Attachment 3

Technical Specification 3/4.2.3 - RCS Flowrate and Nuclear Enthalpy Rise  
Hot Channel Factor

Proposed Change

FIGURE 3.2-3 RCS TOTAL FLOWRATE VERSUS  $R_1$  AND  $R_2$ —FOUR LOOPS IN OPERATION

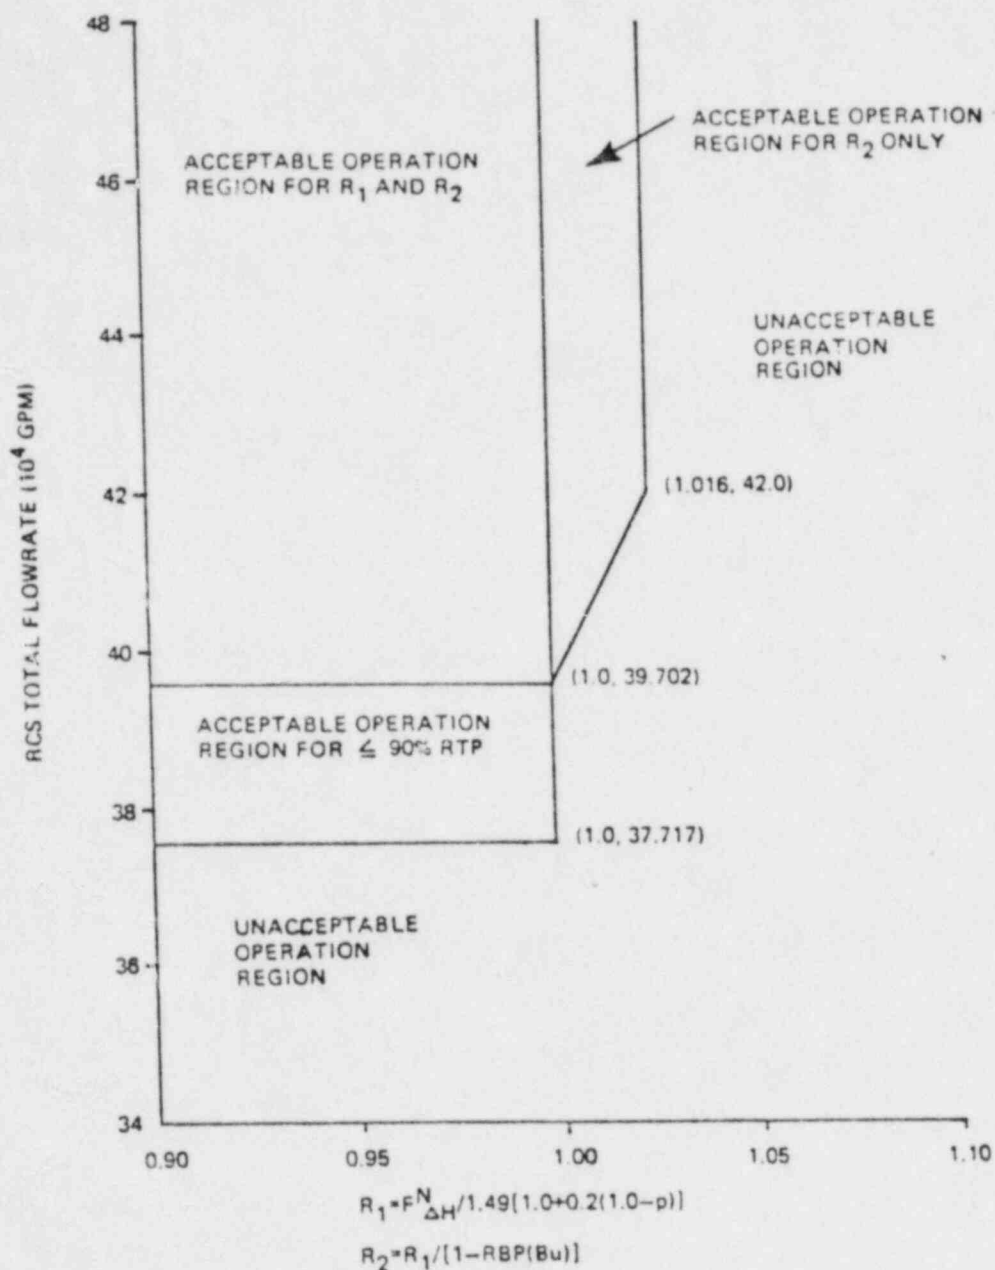
Revise Specification 3.2.3.e and Figure 3.2-3 to reduce the measurement uncertainty for total RCS flow. This results in a decrease in the minimum RCS flow for acceptable operation as shown on Figure 3.2-3. Revise Specifications 4.2.3.2 and 4.2.3.5 to indicate the measurement methods which provide the reduced uncertainty.

PENALTIES OF 0.1% FLOW FOR UNDETECTED FEEDWATER VENTURI FOULING AND FOR MEASUREMENT UNCERTAINTIES OF 1.7% FOR FLOW & 4.0% FOR INCORE MEASUREMENT OF  $F_{\Delta H}^N$  ARE INCLUDED IN THIS FIGURE.

Operation above 90% RATED THERMAL POWER may proceed for no more than 48 cumulative hours provided RCS total flow as measured by precision heat balance is greater than 395,850 gpm.
